Important Notices

TOSHIBA Microcontrollers 900 Family
(TMP91CW12F) (TMP91PW12F) (TMP91CW12AF) (TMP91FY12AF) (TMP91C815F) (TMP91C016F)
(TMP91CW18AF) (TMP91PW18AF) (TMP91C219F) (TMP91C820AF) (TMP91CY22F)
(TMP91FY22F) (TMP91C824F) (TMP91C025F) (TMP91CK27U) (TMP91CP27U)
(TMP91CP27RUG) (TMP91CU27U) (TMP91CU27RUG) (TMP91FY27U) (TMP91CW28FG)
(TMP91CY28FG) (TMP91FY28FG) (TMP91C829F) (TMP91C630F)
(TMP92C820FG) (TMP92CH21FG) (TMP92CM22FG) (TMP92CA25FG) (TMP92CM27FG)
(TMP92CD54IF) (TMP92FD54AIF)
(TMP94C241CF) (TMP94C251AF)

Restriction on Use of 8-bit Timers

Datasheet Modifications: PWM Cycle of 8-bit Timers

Example when using PWM mode

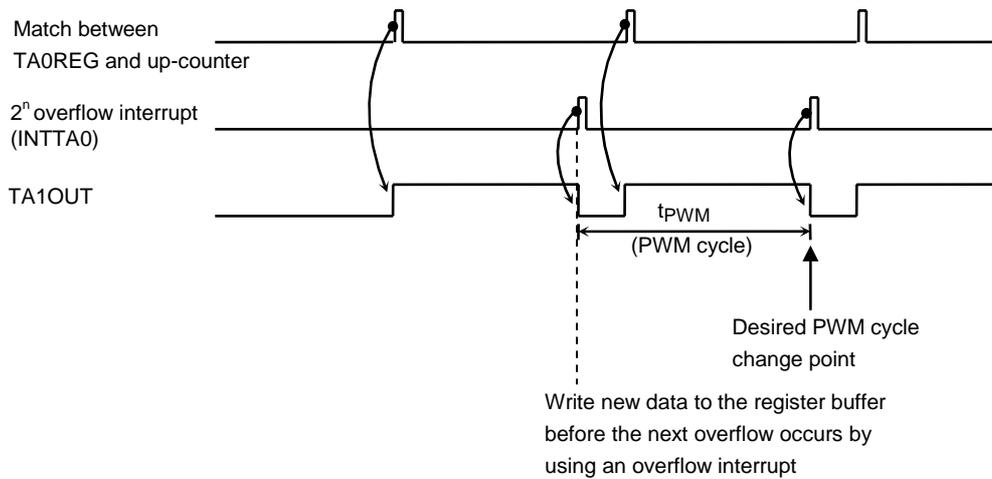
When the double buffer is enabled for an 8-bit timer in PWM or PPG mode, caution is required as explained below.

If new data is written to the register buffer immediately before an overflow occurs by a match between the timer register value and the up-counter value, the timer flip-flop may output an unexpected value.

For this reason, make sure that in PWM mode new data is written to the register buffer by six cycles ($f_{sys} \times 6$) before the next overflow occurs by using an overflow interrupt.

In the case of using PPG mode, make sure that new data is written to the register buffer by six cycles before the next cycle compare match occurs by using a cycle compare match interrupt.
